AFFIDAVIT OF REMAINING MONUMENTATION

I, Paul D. Galli, being first duly sworn, depose and say that in accordance with O.R.S. 92.070(3)(b), I have correctly surveyed and marked with proper monuments the remaining lot corners as indicated on the plat of Rivercrest Estates 2, Phase 2 (Volume 22, Page 56), instrument number 2007-019725, as recorded in Plat Records of Douglas County. Said interior corners were set on March 21, 2008.

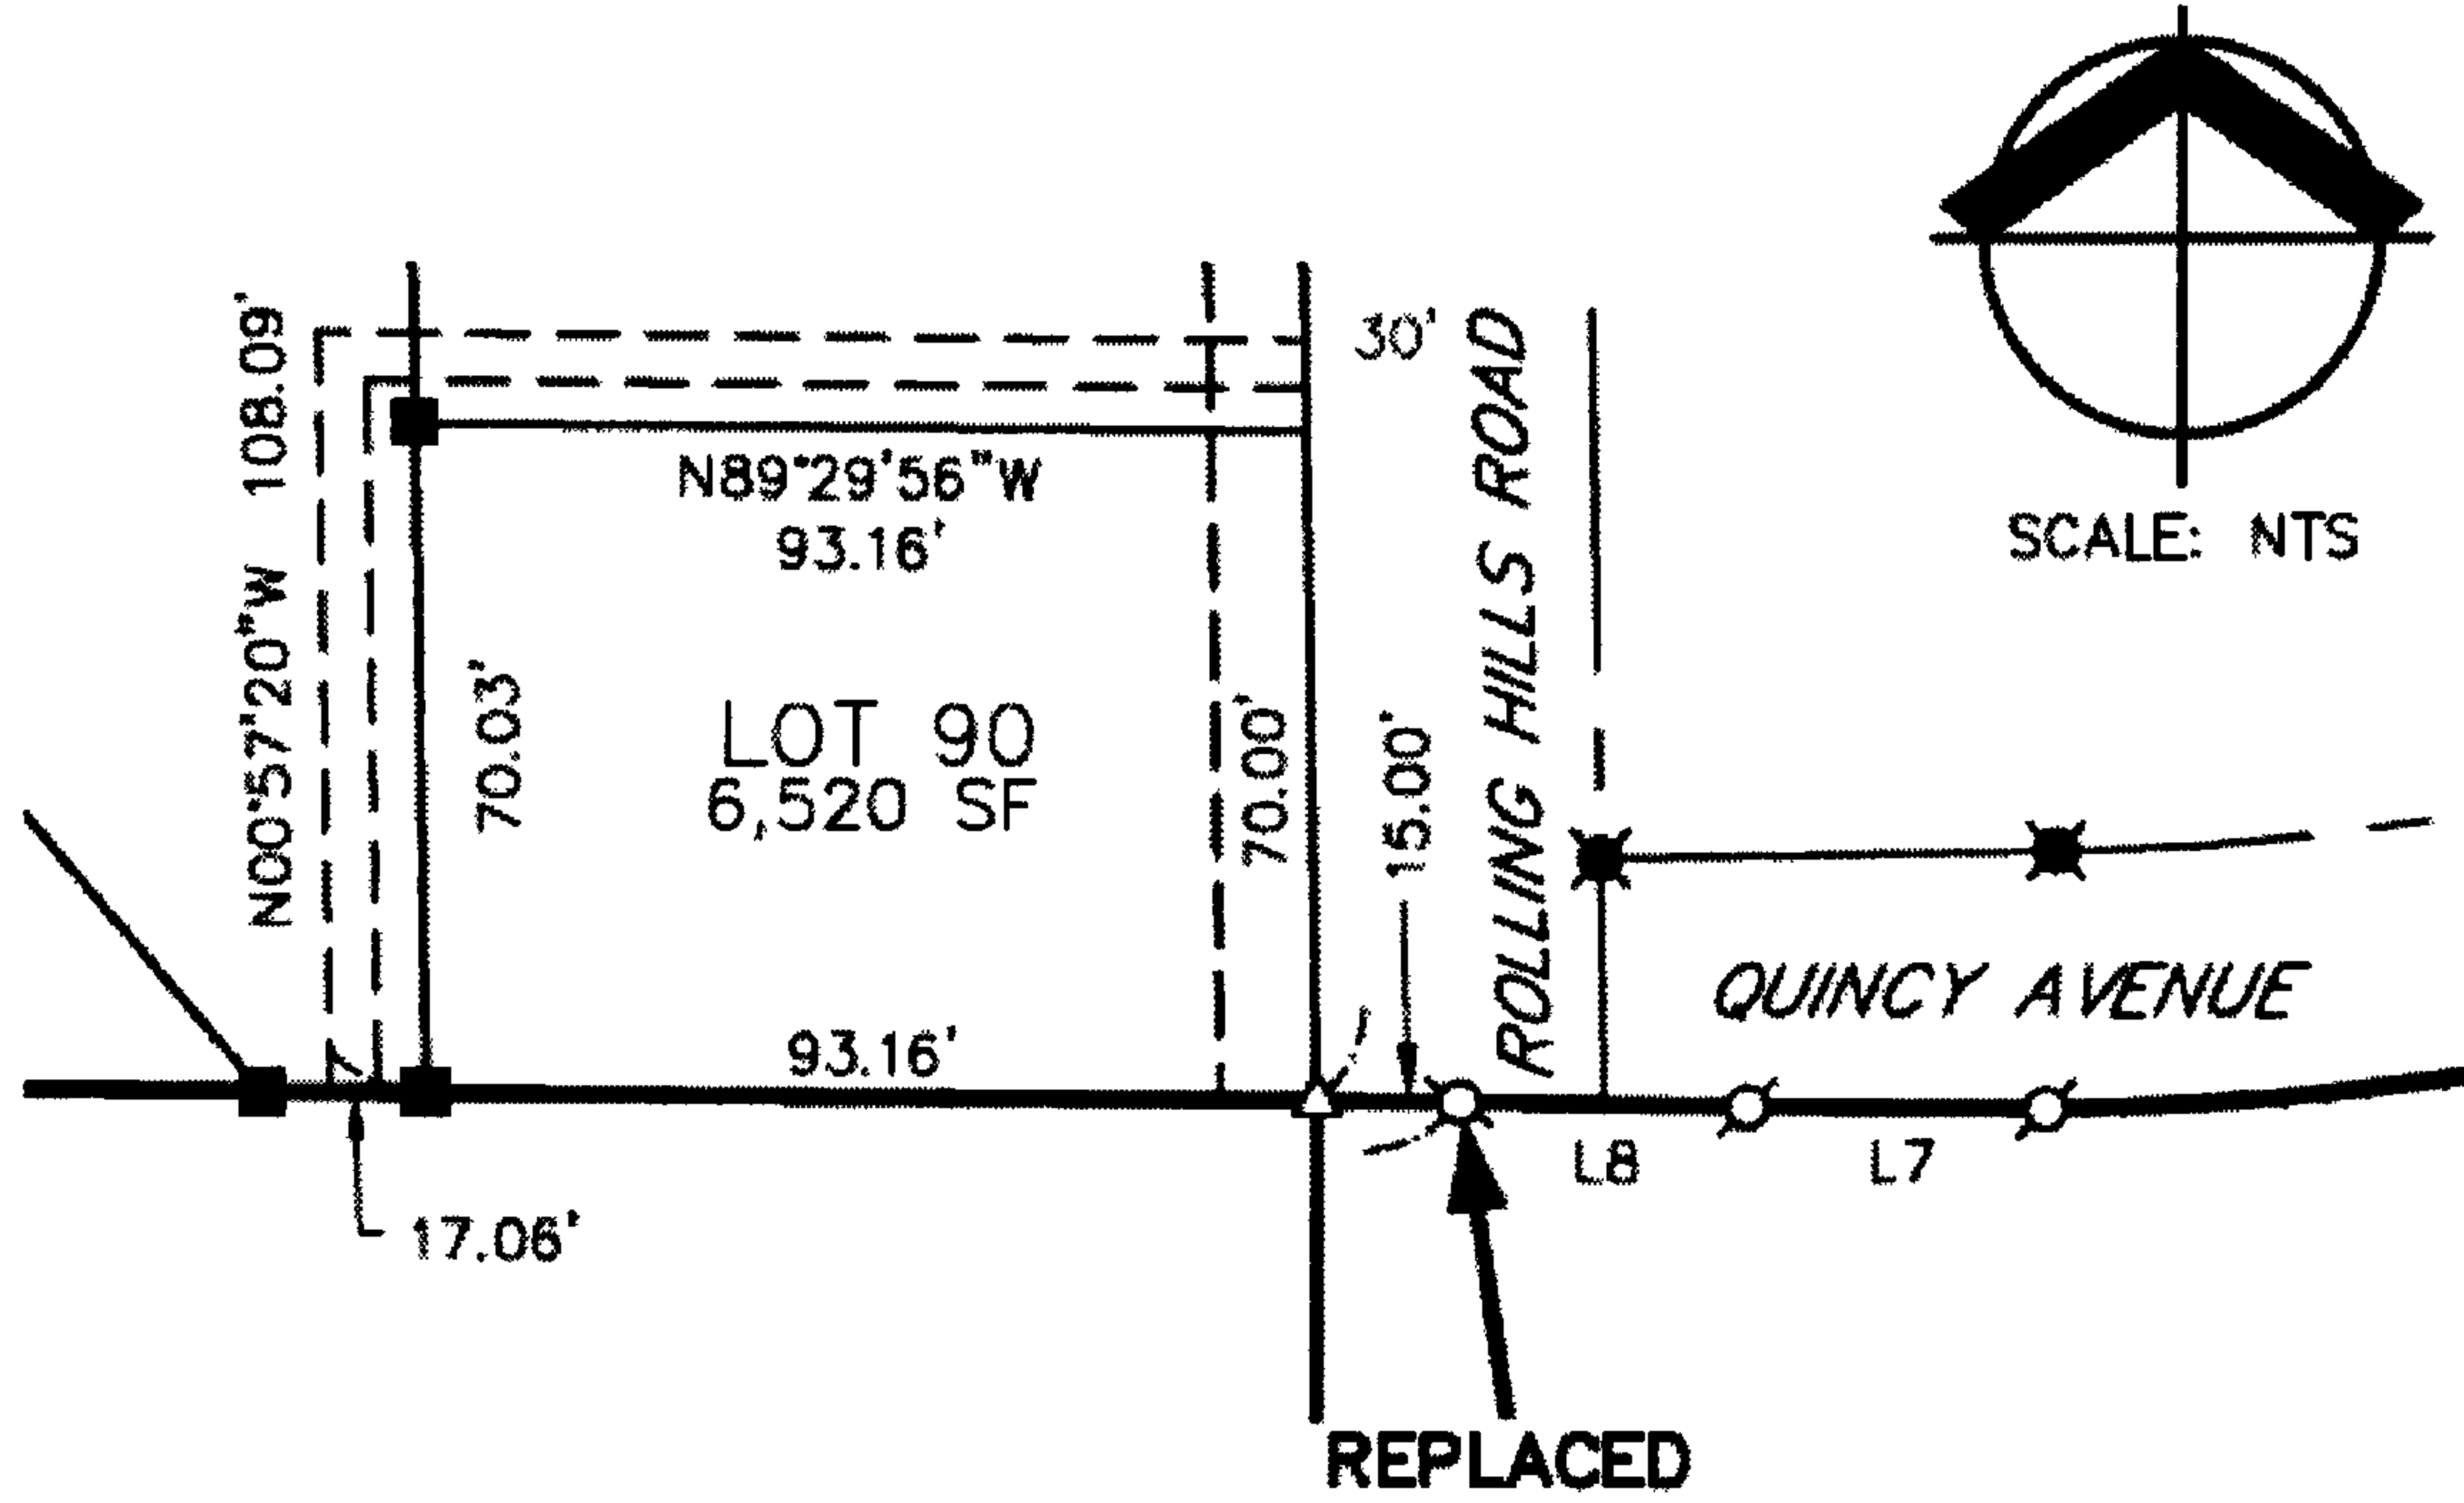
6) At the northeast corner of lot 53 the 5/8" iron rod with yellow plastic cap marked "I.E. ENGINEERING" was destroyed during construction a 5/8" by 30" iron rod with yellow plastic cap marked "WRG DESIGN INC." was set as a reference monument being North 89°35'22" West, 1.00 feet from the original location due to conflict with a telephone pedestal.
